TOWN OF VIENNA, VIRGINIA

WALL WAIVER REQUEST

NAME OF PROJECT: Cadence on Center ACREAGE: 1.03 Acres

Re: Cadence on Center Property
Request for a Waiver of the Masonry Wall Requirement

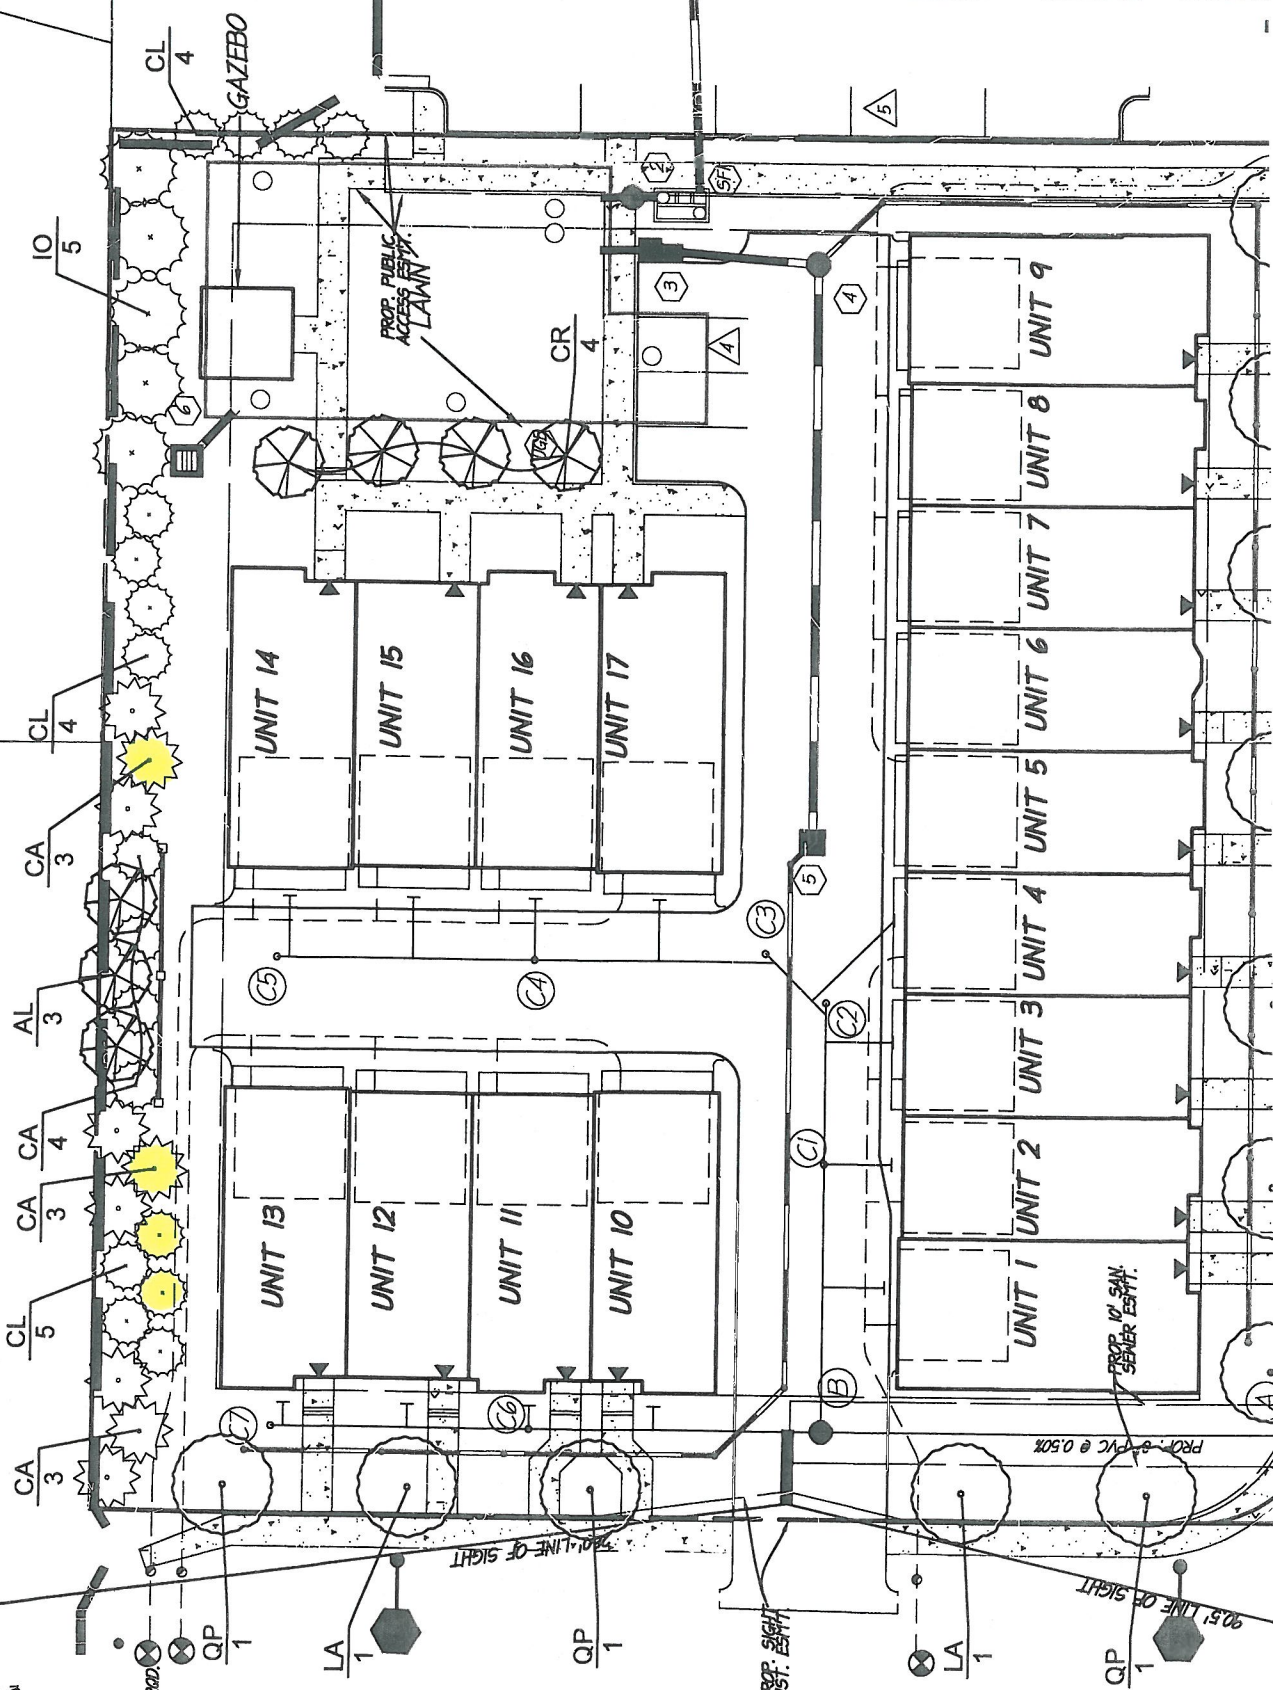
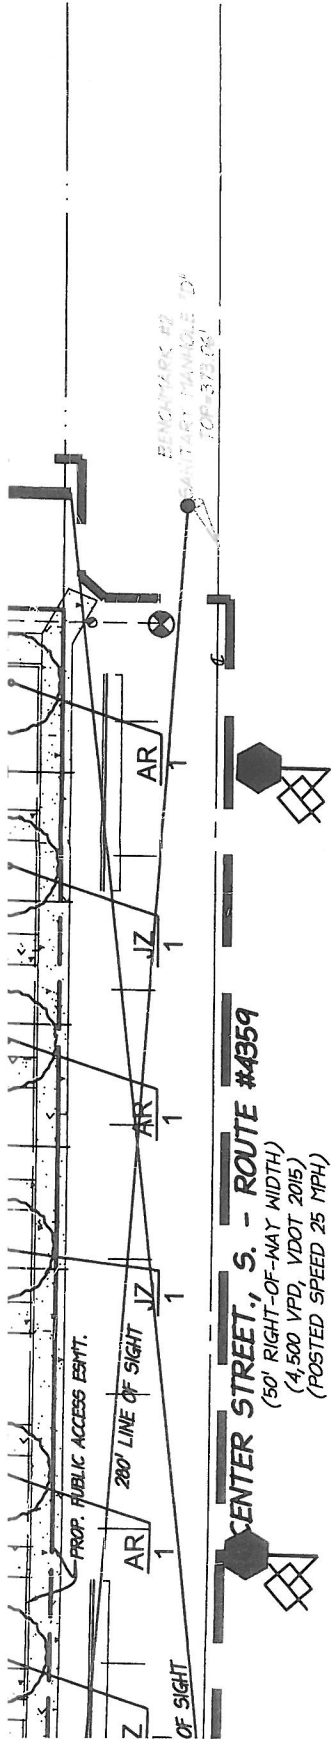
The Applicant respectfully requests your review and approval of a waiver Zoning Ordinance requiring the construction of the masonry wall in lieu of additional landscaping and larger tree sizes from the approved plan as attached. Our justifications for the request are as follows:

1. The current western boundary contains a six (6) foot tall wood fence on the common boundary providing ample screening.
2. The trees on the approved plan are 2" – 2 ½" caliper and/or 6'-7' tall trees.

3. The current masonry wall on the approved site plan will provide no further screening than the existing wood fence (see attached photo).
4. The current masonry wall on the approved site plan will be detrimental to the roots, growth and trimming of the proposed landscaping.

5. The applicant is proposing to add four (4) additional evergreen trees for screening as well as increasing the size of the all the Evergreen trees to the larger from 6' – 7' size to 8' – 10' size to provide a more immediate screening (see attached plan).

6. The applicant is proposing to install a 45-foot section of 6-foot-tall masonry wall at the end of the turnaround to make ensure that vehicular lights do not shine onto the neighbor's yard.

8. The applicant, per the neighbors and the Town of Vienna Arborist suggestions, move the trees away from the property line, change the species to native species and placed the new trees in the more desired locations.
